CITY OF MILL CREEK DESIGN REVIEW BOARD APPLICATION PL2020-0013

NAME OF PROJECT: Central Market Exterior Remodel

PROPOSAL: Proposed revisions to building elevations and landscaping

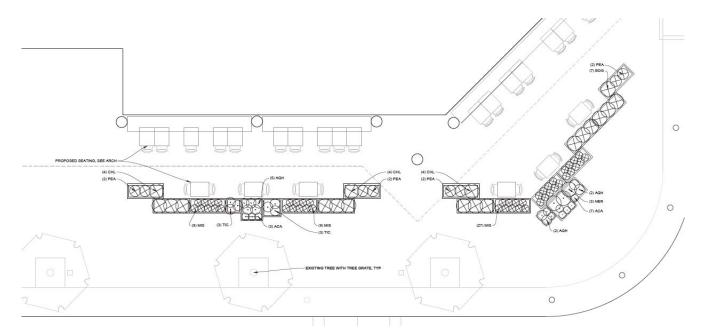
Proposed materials will be arranged in horizontal bands of varying width and vertical patterns to help break up the building bulk and create prominent entry points. New windows and doors will be added and covered to prevent roof run off dripping onto customers/employees, see **Attachment 3 – Building Elevations**, Floor Plans and Wall Sections (Sheets A201-202 and A301-302) for a sections of the rooflines. As you can see on **Attachment 2 – Sheet 5**, the material type for the base of the outdoor bench has yet to be determined, so as a Condition of Approval staff is recommending that the applicant select a material type that is complimentary to the overall design.

As proposed with the one condition noted above, staff believes that the building elevations and materials are in compliance with the design guidelines contained in the MCMC 17.34.
